Percolation Test Report; 10865 Braeburn Drive, Columbia, MD

Re: Braeburn, Lot 13  
10865 Braeburn Road  
Percolation Certification Plan

Date:	June 28, 2018
Attention:	Hank Oswald
Re:	10865 Braeburn Drive Braeburn, Lot 13 Percolation Certification Plan
Project #:	18-001

### PERCOLATION CERTIFICATION PLAN

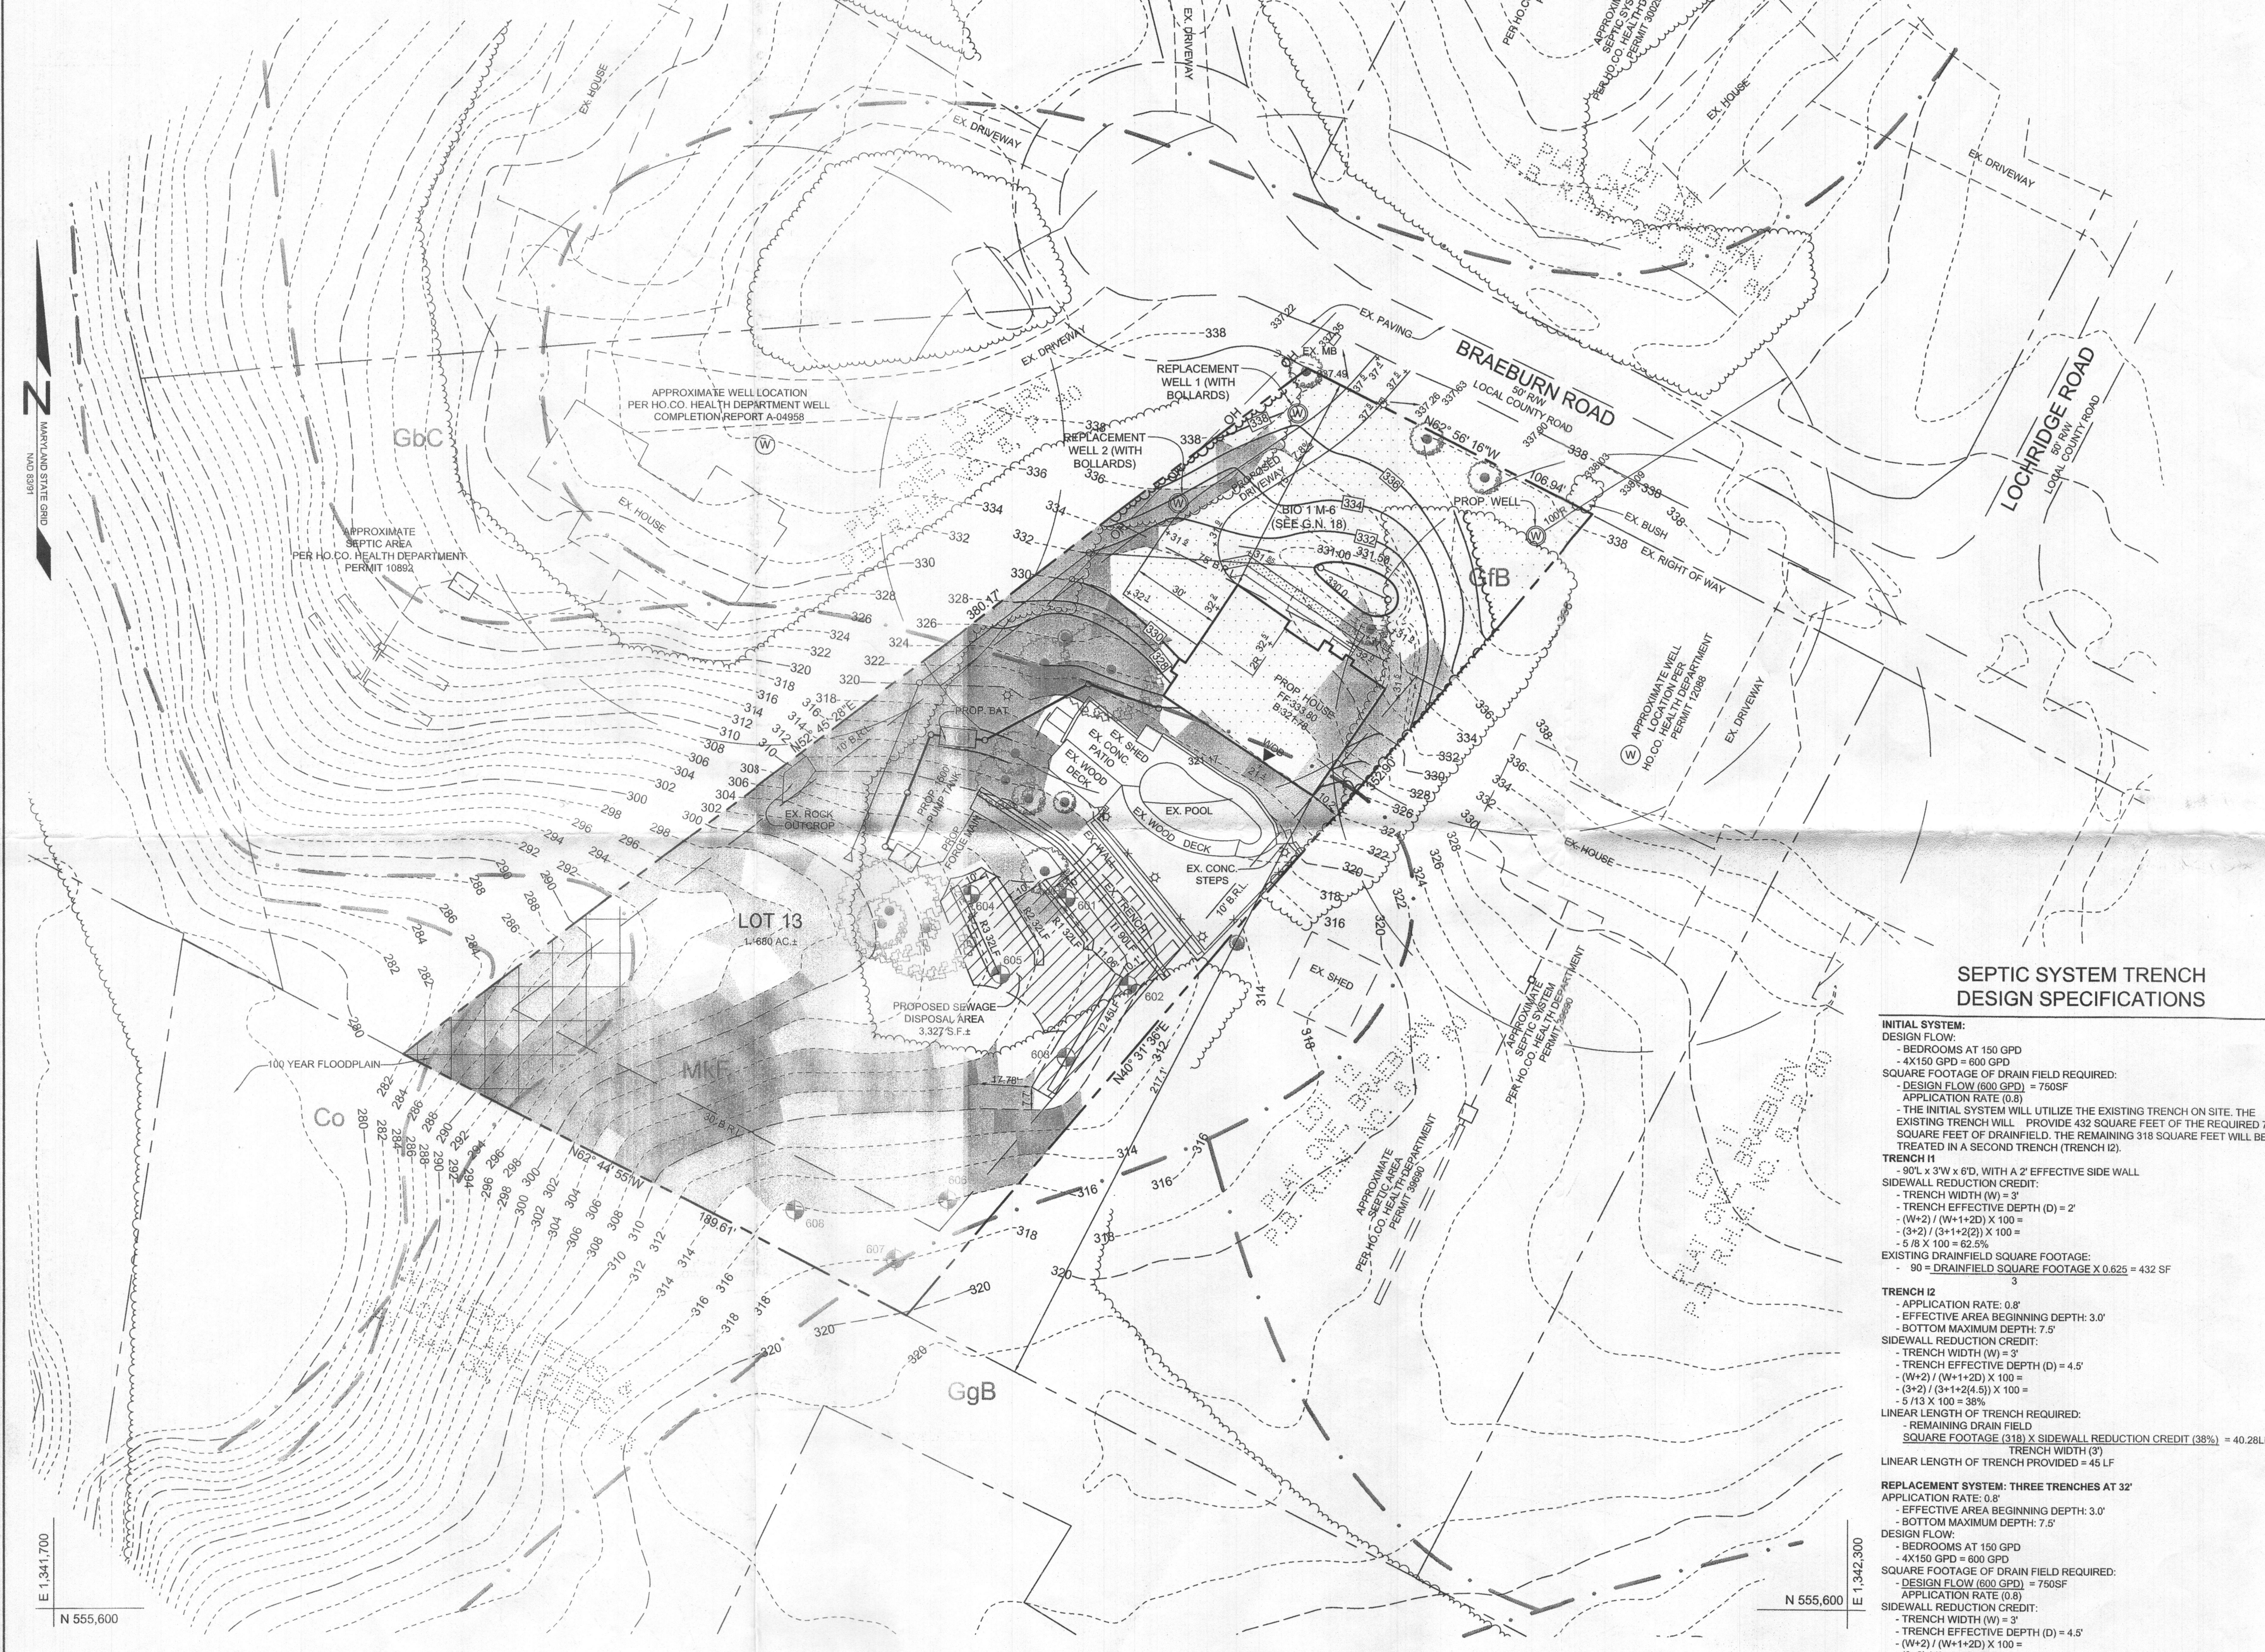
The plan looks good but the DW is within 100 feet of the alternate well site. Move it down the hill as suggested. Any issues, please contact me.

The perc cert plan for 10865 Braeburn Drive was rejected due to the following comments:

1. Show 3<sup>rd</sup> well site along driveway and property line while relocating DW. down the hill.
2. Relocate pump tank so it pumps up to both systems
3. Show neighboring wells and septic systems (See attachments for Lots 12 and 14)

Michelle Dwyer  
~~Boat American~~  
Rover  
Move  
DW 100  
away from  
well

Good afternoon. You may omit the drywell now on the revised perc cert plan but we would like a letter to accompany the plan acknowledging that if for some reason DED does not approve your drywell design in the proposed location, it will likely place delays on the project in the future until a solution can be reached.

Using MEP for SWM we are proposing to use impermeable liner on the drywell. If you notice General Note 18 was updated to show this. The outfall for the drywell is going the outfall system for the bio-retention facility. We can't move it downhill due to setbacks and steep slopes. I'm considerate of the intention of the setback and think this alternative will support the intention of the regulation.
